FIELD SERVICE BULLETIN

FSB Number: LVCCFSB2005-61
 Authors: Darwin Garcia
 Date: March 11, 2005
 Total No. of Pages: 2
 Subject: **MPX220 SIM Connector Pins Buckling**
 Model Affected: **MPX220**
 Level of Repair: 3

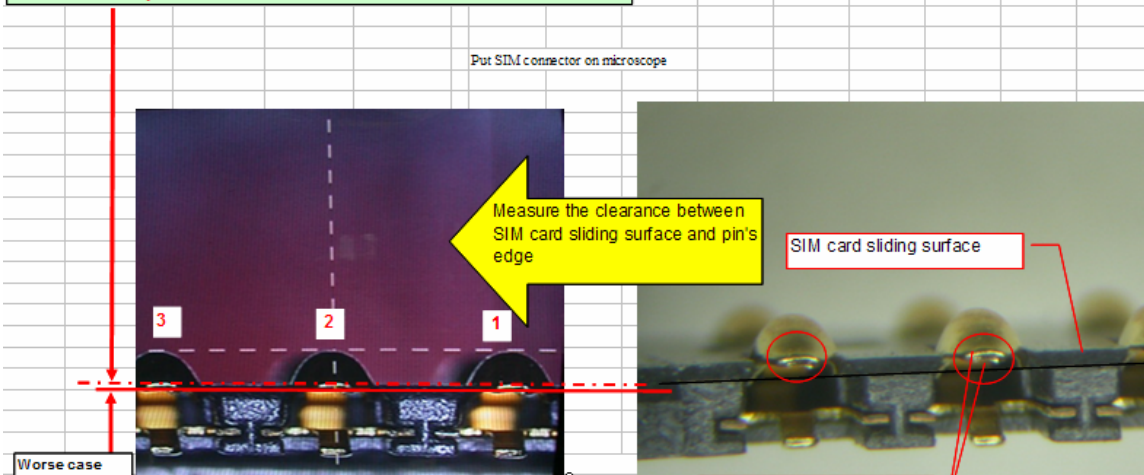
The clearance between the SIM card sliding surface and pin's edge is too high in some connector, however failing part were within the original specs.

The clearance could be 0.049 mm in some cases and such small clearance may cause SIM card to impact on the pin's upper edge and bend the pins.
